Access Compliance Report

Public Rights-of-Way

(Pedestrian Signals)

Intersection ID: N/A	Main Street:	Cross Street: N/A	Location: N/A
ADA ID: CBD0BA938033	Signal Type: One Push Button-Non APS	Overall Compliance: No	Severity Score: BTN 1: N/A BTN 2: N/A No BTN: N/A
Codes/Mitigation Info/Possible Solution		Field Measurements/Component Compliance

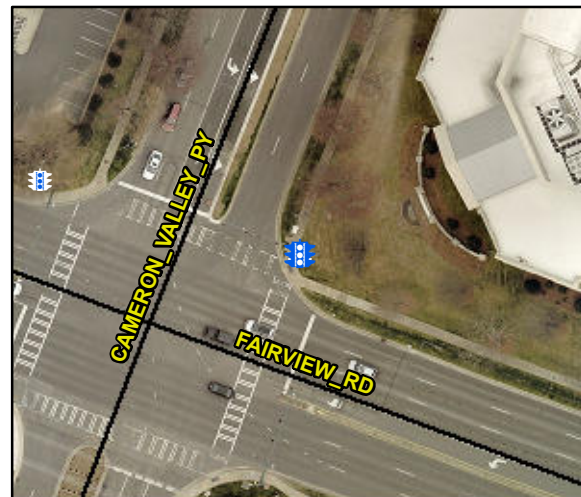
N/A	B 1 FWD Approach Width (in)	N/A	N/A	B 2 FWD Approach Width (in)	N/A
N/A	B 1 FWD Approach Obstruction?	N/A	N/A	B 2 FWD Approach Obstruction?	N/A
N/A	B 1 FWD Approach Obstruction Dist (in)	N/A	N/A	B 2 FWD Approach ObstructionDist (in)	N/A
No	B 1 PARA Approach?	No	N/A	B 2 PARA Approach?	N/A
N/A	B 1 PARA Approach Constrained?	N/A	N/A	B 2 PARA Approach Constrained?	N/A
N/A	B 1 PARA Approach Reach (in)	N/A	N/A	B 2 PARA Approach Reach (in)	N/A
N/A	B 1 PARA Approach Width (in)	N/A	N/A	B 2 PARA Approach Width (in)	N/A
N/A	B 1 PARA Approach Obstruction?	N/A	N/A	B 2 PARA Approach Obstruction?	N/A
N/A	B 1 PARA Approach Obstruction Dist (in)	N/A	N/A	B 2 PARA Approach ObstructionDist (in)	N/A
Yes	B 1 Clear Floor Space Slope (%)	0.1	N/A	B 2 Clear Floor Space Slope (%)	N/A
Yes	B 1 Clear Floor Space XSlope (%)	0.2	N/A	B 2 Clear Floor Space XSlope (%)	N/A
N/A	B 1 PAR Slope (%)	2.4	N/A	B 2 PAR Slope (%)	N/A
No	B 1 Height (in)	59.0	N/A	B 2 Height (in)	N/A

Yes	B 1 Clear Xing Direction?	ClearlyMarked	N/A	B 2 Clear Xing Direction?	N/A
	B 1 Crossing Direction	To SW		B 2 Crossing Direction	N/A
Yes	B 1 DistanceTo XWalk (in)	0.0	N/A	B 2 DistanceTo XWalk (in)	N/A
No	B 1 DistanceTo Curb (in)	109.0	N/A	B 2 DistanceTo Curb (in)	N/A
Yes	B 1 Diameter (in)	2.0	N/A	B 2 Diameter (in)	N/A

Possible Solutions: Replace Signal Push Button With APS Button on New Post. Remove & Replace Sign.

PROW/ADA: R209.1, TMUTCD 4e.08, R404.7.1, R404.7.2, R406
